Date: 2/14/08
To: All Contractors/Vendors
From: Linda M. Martin, Clerk
Subject: Addendum Number: 3
Project Name: Eddy Street Commons Phase II Parking Garage
Project Number: 108-004

ADDENDUM # 3

PROJECT: Eddy Street Commons Phase II Parking Garage
1200 Edison Road
South Bend, Indiana

**Addendum No. 3
February 14, 2008**

Reference Drawing: P204

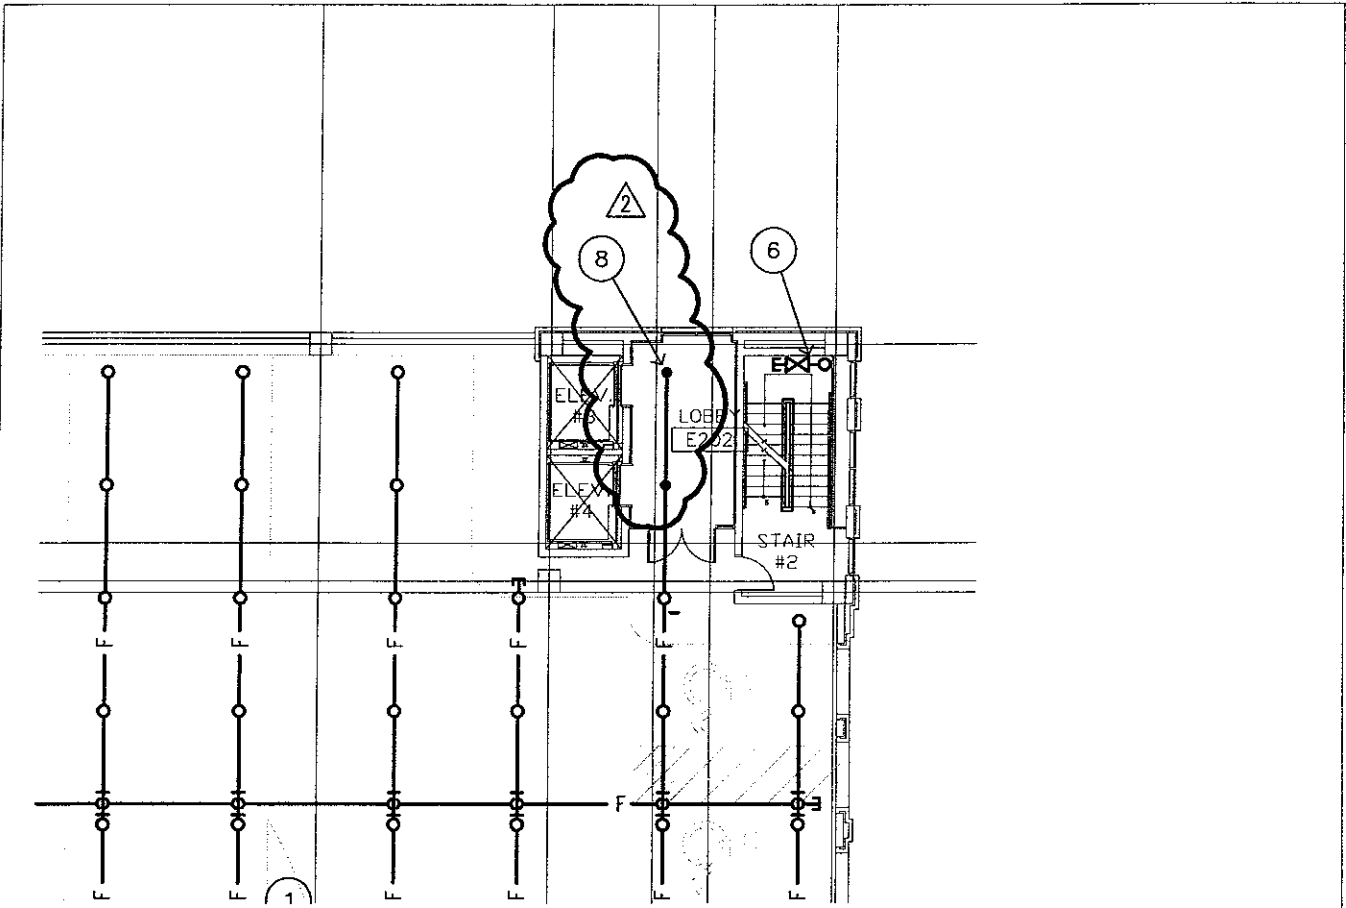
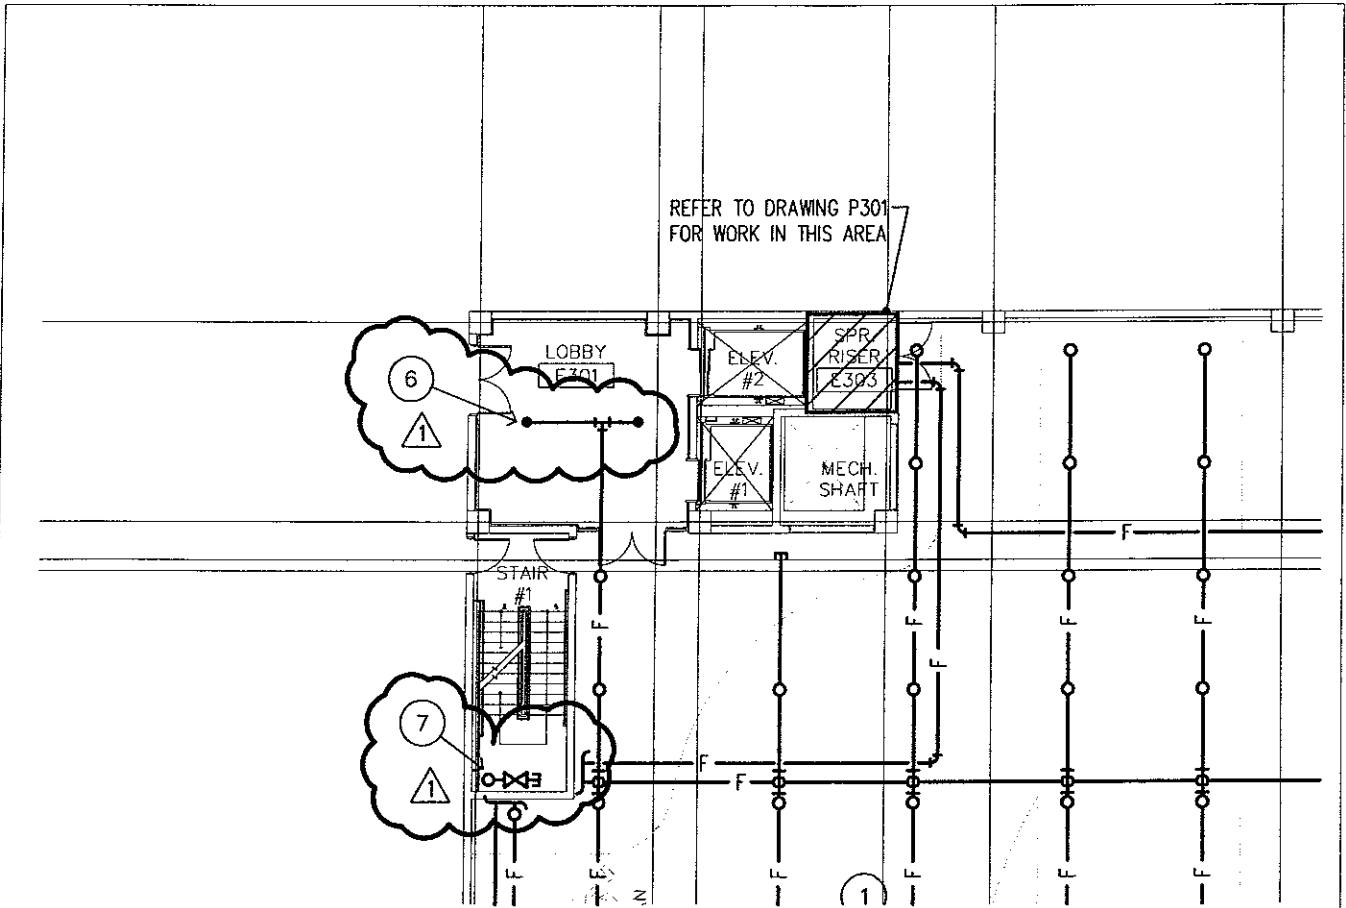
1. Change upright sprinkler heads in elevator lobbies to recessed pendant sprinkler heads as shown on attached Sketches P-SK006 and P-SK007.

Addendum No. 3
02-14-08
Reference Drawing: P205
Revision Number: ①
Drawn by: REM Checked by: GAC
Project No.: 108-004 Scale: 1/16" = 1'-0"
Drawing No.:
P-SK008

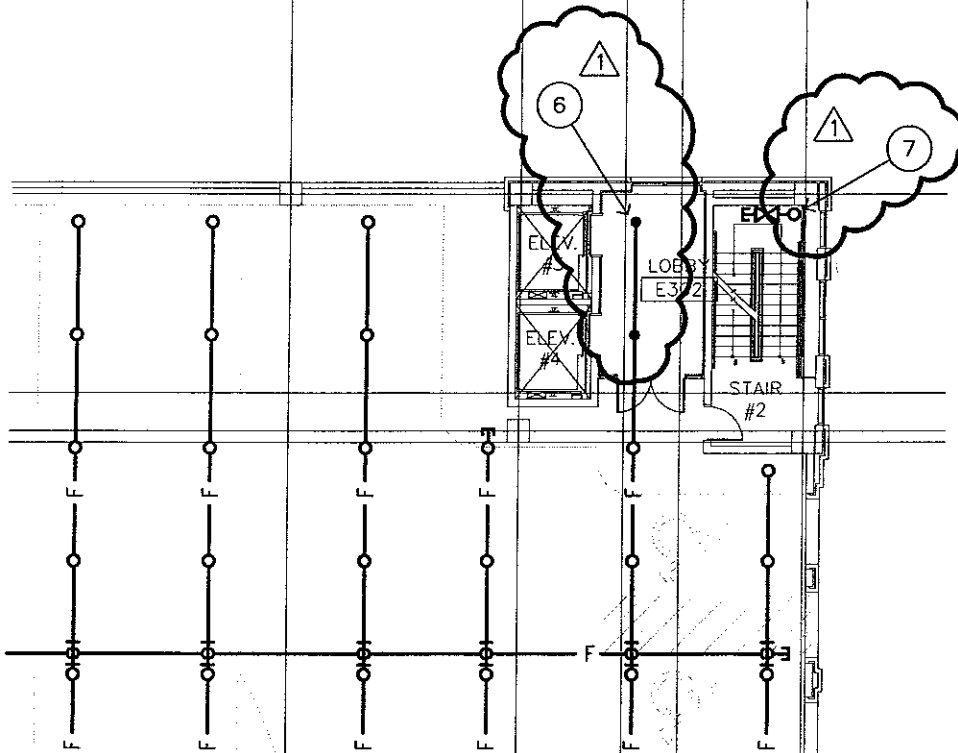
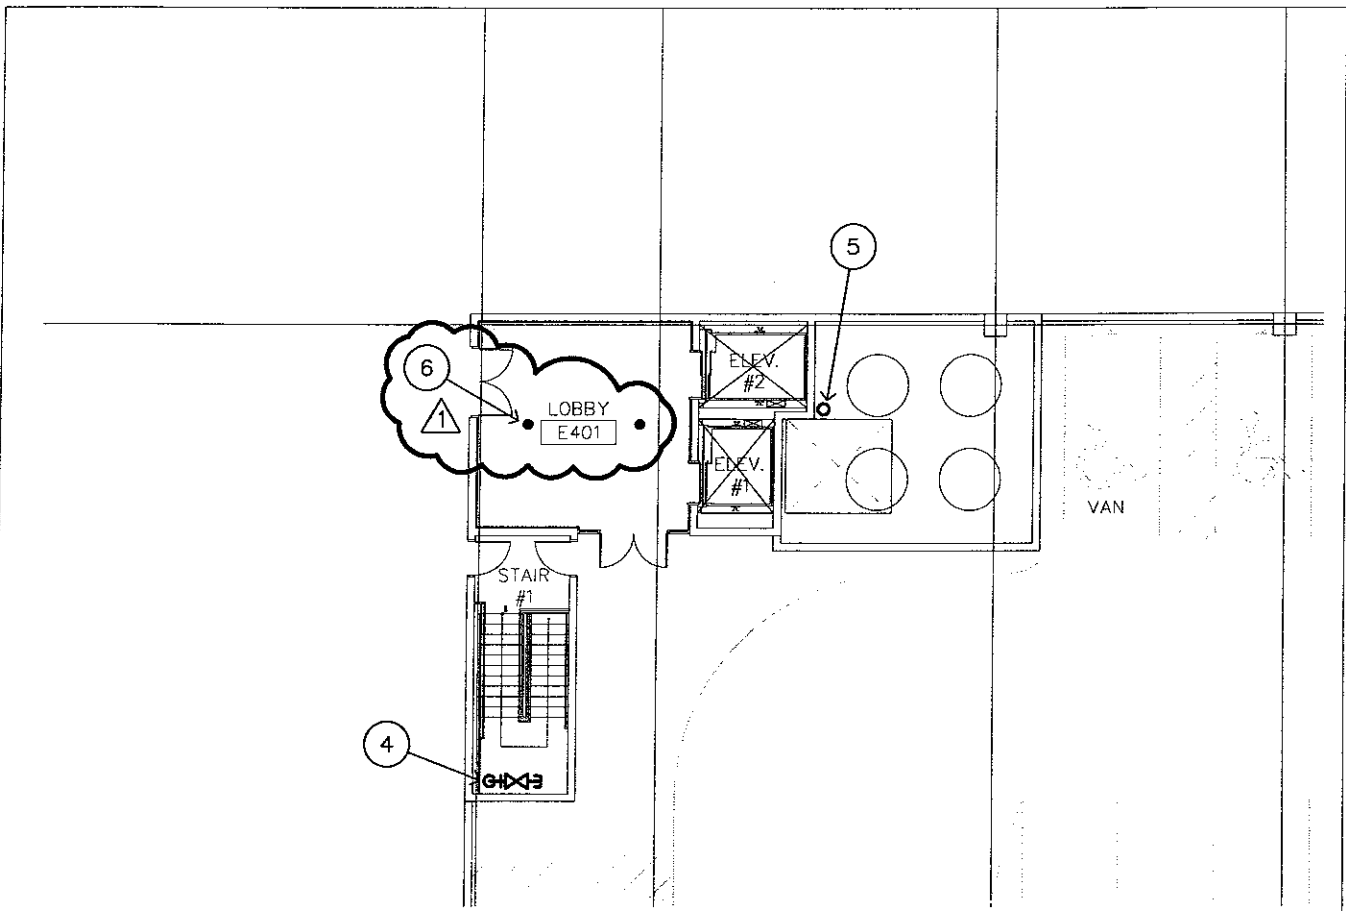
1. Change upright sprinkler heads in elevator lobbies to recessed pendant sprinkler heads as shown on attached Sketches P-SK008 and P-SK009.
2. Revise location of dry standpipes and add Plan Note 7 as shown on attached Sketches P-SK008 and P-SK009.

Reference Drawing: P206

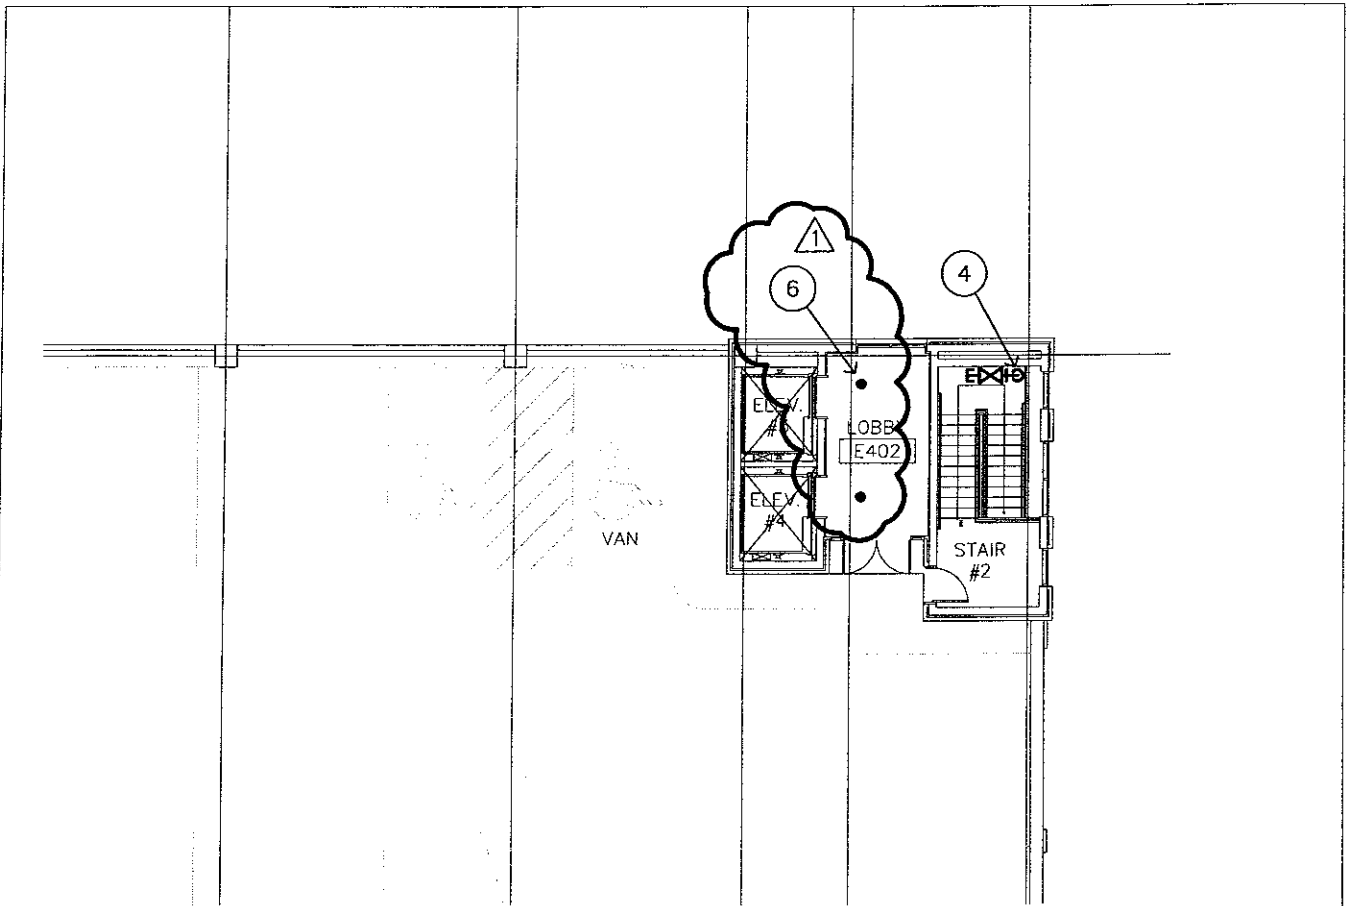
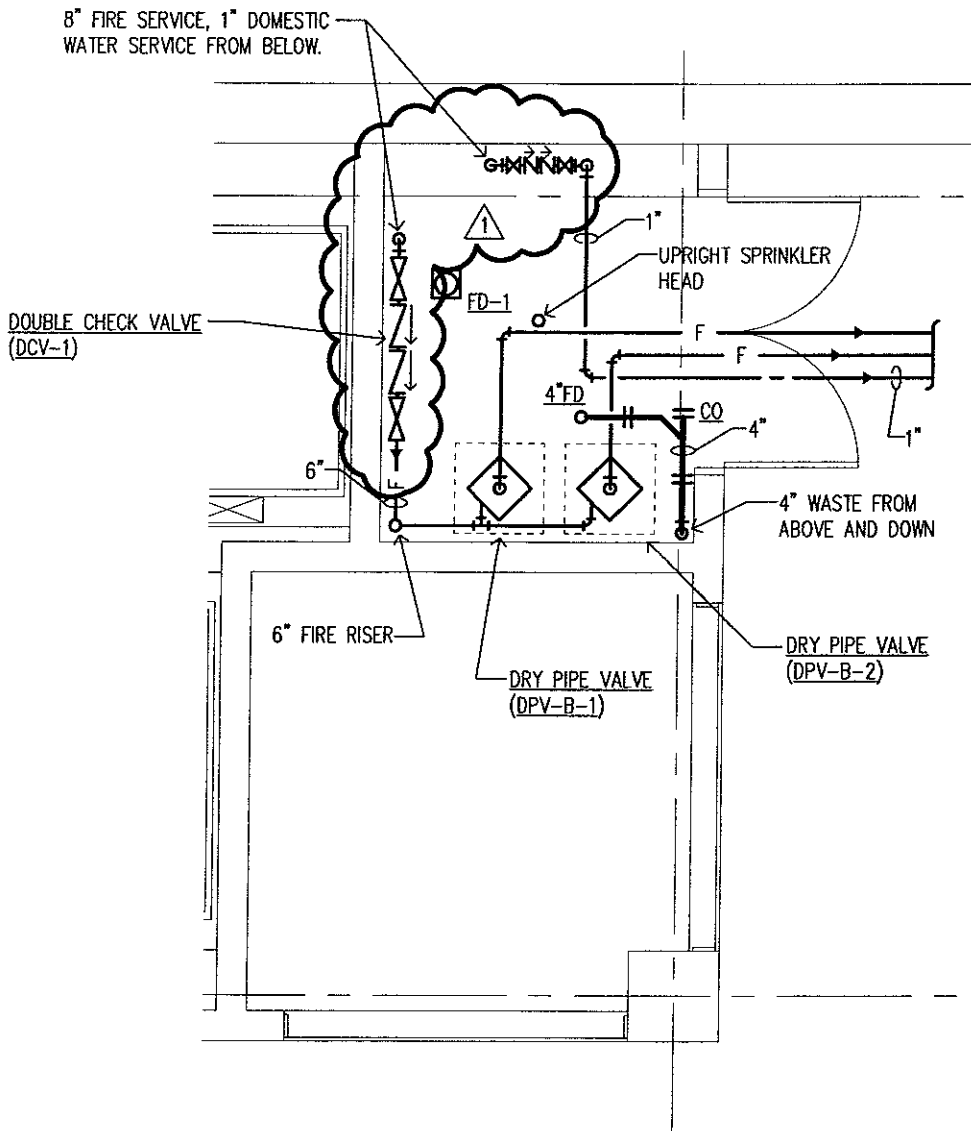
1. Add recessed pendant sprinkler heads and associated plan note to elevator lobbies as shown on attached Sketches P-SK010 and P-SK011.

Reference Drawing: P301

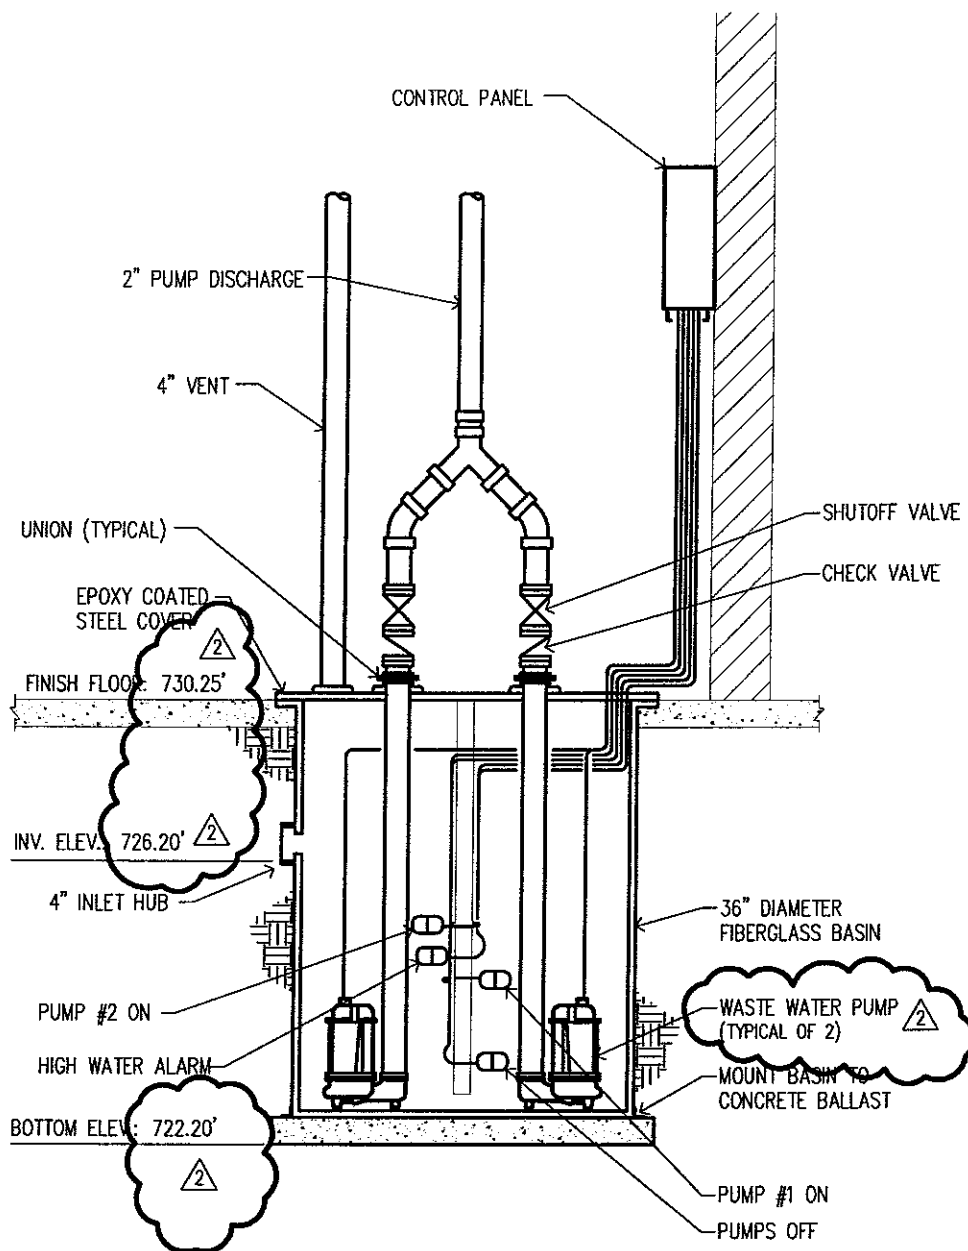
1. Revise incoming domestic water and fire service as shown on attached Sketch P-SK012.

Reference Drawing: E001

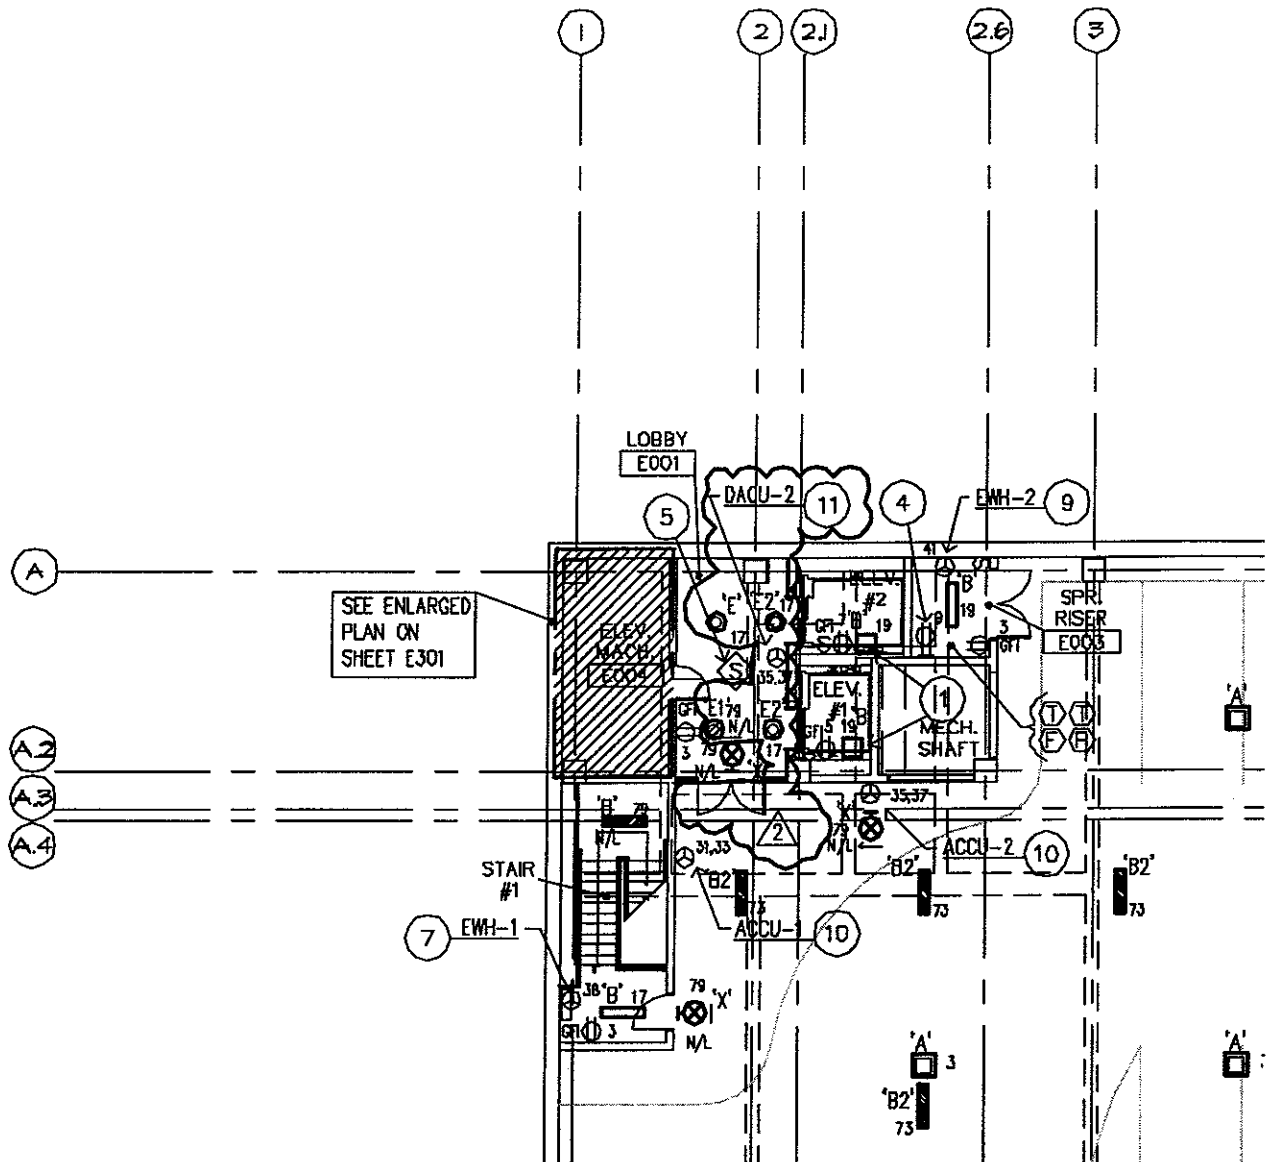
1. Add the following Project Electrical General Notes
 - a. **CCTV/SECURITY SYSTEM**
 - i. **ELECTRICAL CONTRACTOR TO PROVIDE ALL ROUGH-INS, CONDUIT AND PULL WIRE BETWEEN ROUGH-INS AND HEAD END EQUIPMENT. HEAD END EQUIPMENT SHALL BE LOCATED IN ELECTRICAL ROOM IN BASEMENT ON THE WEST EQUIPMENT TERMINAL BOARD.**
 - ii. **COORDINATE FINAL ROUGH-IN LOCATIONS WITH SYSTEMS CONTRACTOR.**
 - iii. **REFER TO CARD READER DETAILS ON DRAWING E502 FOR ADDITIONAL INFORMATION.**
 - iv. **PROVIDE BLANK PLATES ON ALL ROUGH-INS.**

- i. **ELECTRICAL CONTRACTOR TO PROVIDE ALL ROUGH-INS, CONDUIT AND PULL WIRE BETWEEN ROUGH-INS AND HEAD END EQUIPMENT. HEAD END EQUIPMENT SHALL BE LOCATED IN ELECTRICAL ROOM IN BASEMENT ON THE TELEPHONE TERMINAL BOARD.**
 - ii. **COORDINATE FINAL ROUGH-IN LOCATIONS WITH SYSTEMS CONTRACTOR.**
 - iii. **ROUTE 1" CONDUIT AND PULL WIRE FROM EMERGENCY PHONE ROUGH-IN TO TELEPHONE TERMINAL BOARD IN ELECTRICAL ROOM IN BASEMENT.**
 - iv. **PROVIDE BLANK PLATES ON ALL ROUGH-INS.**
2. Add/change electrical symbols. See attached Sketch E-SK002,
